Subject: Duke Energy Carolinas, LLC
William States Lee III Nuclear Station - Docket Nos. 52-018 and 52-019
AP1000 Combined License Application for the
William States Lee III Nuclear Station Units 1 and 2
Response to Request for Additional Information
Ltr# WLG2008.12-14

Lee Nuclear Station Response to Request for Additional Information (RAI)

Reference NRC RAI Number: ER RAI-78

Figure 1 Make Up Pond A Dredging Footprint

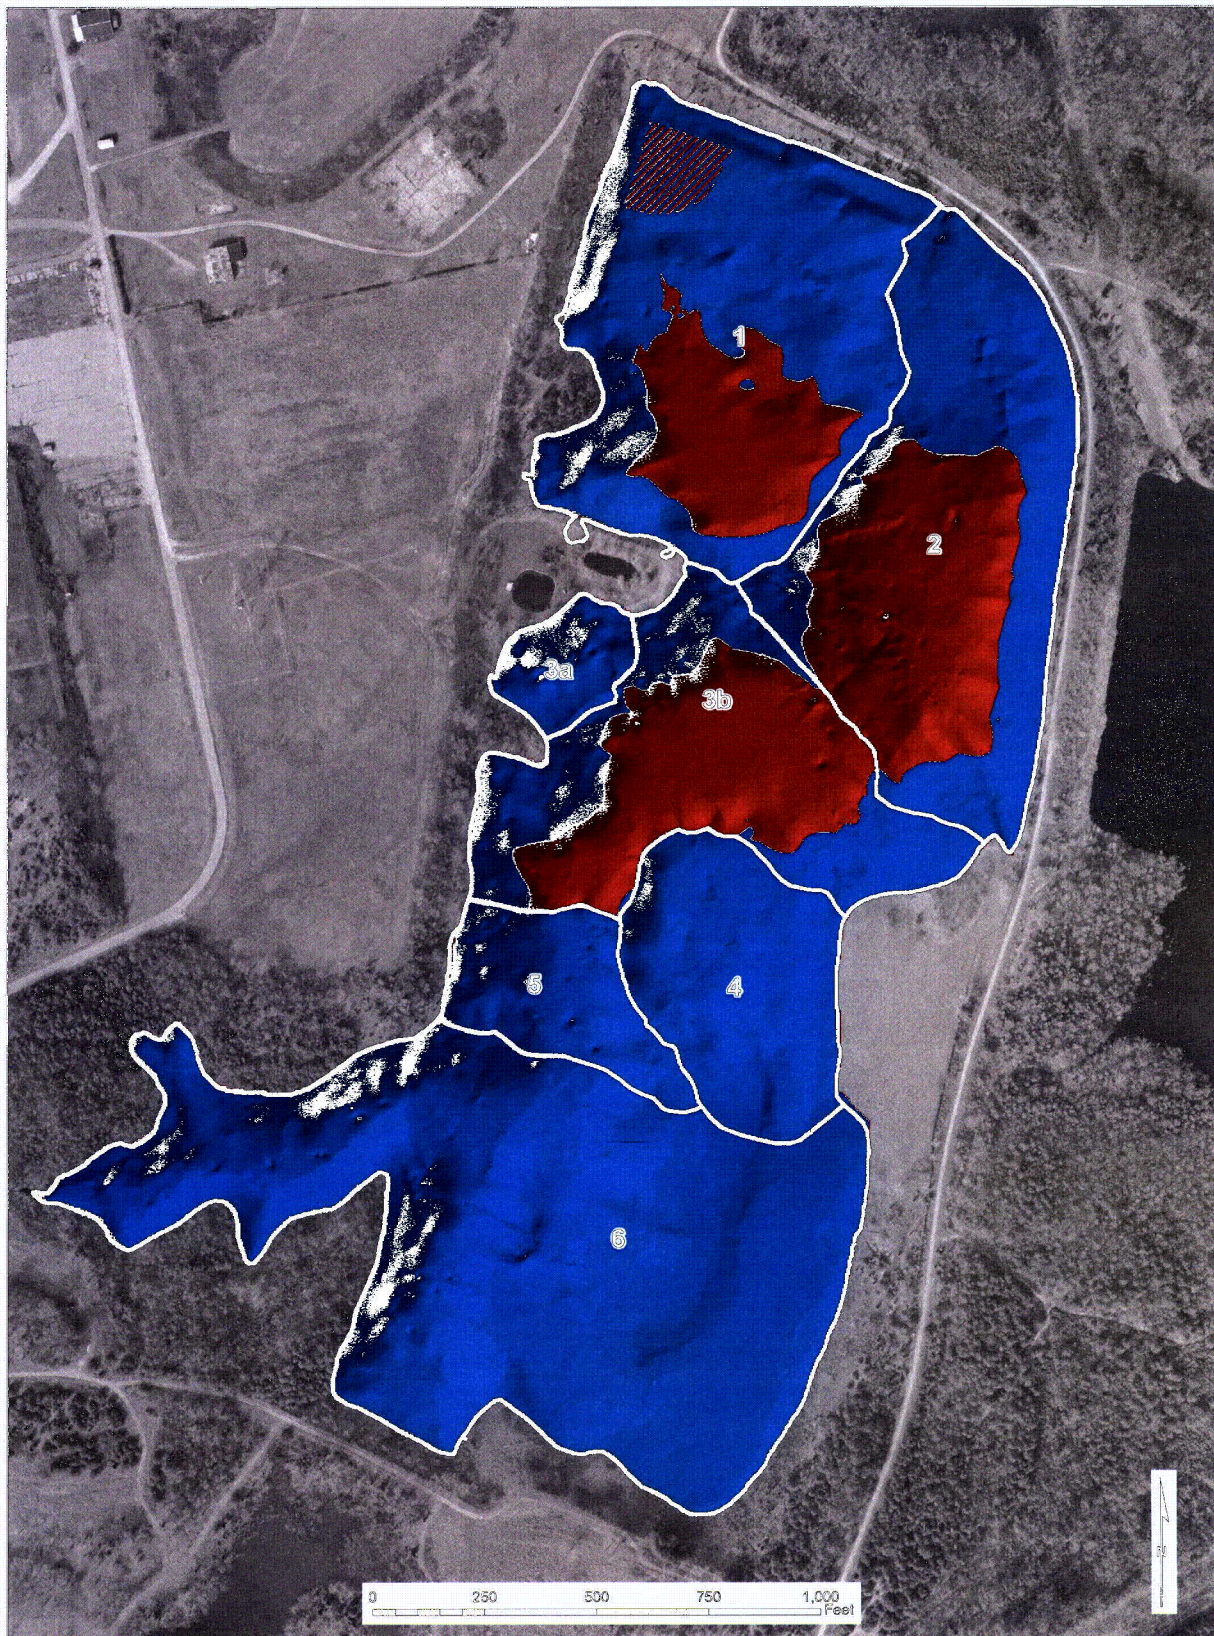
Provide the foreseen frequency of dredging, dredging footprint (ft²), dredging depth (ft) and quantity of dredged material (yds³) to be removed from the Broad River intake and discharge structures and for the intake structures of Make-up Ponds A and B. Indicate the location(s) for dredged material deposition in each case.

Based on total suspended sediment samples collected in the Broad River during 2007, an evaluation of sediment deposition rates was performed for Make Up Pond A (Pond A). Sediments entering Pond A from the proposed location of the discharge structure (denoted by the red cross-hatched area) will generally settle in the areas graphically depicted in red on Figure 1. These areas are deeper holes within the pond with Area 2 being the deepest at a maximum depth of 30 ft. (ft.) and Areas 1 and 3b ranging from 9 to 13 ft. in depth. Based on pumping rates of 78 and 104 cubic feet per second (cfs) into Pond A, it is anticipated that dredging will be necessary every 15 – 26 years. The dredging footprint at 517 ft. mean sea level (msl) is expected to be approximately 689,400 square feet (ft²) and the maximum dredging depth is expected to be 30 ft. with the average being in the range of 9 to 13 ft. The quantity of dredged material is estimated to be 407,400 cubic yards (yds³).

Note that due to the fine particle size and associated settling rates, sediment particles will not deposit inside the discharge structure itself. Therefore, it is not anticipated that the discharge structure in Pond A will need to be dredged out.
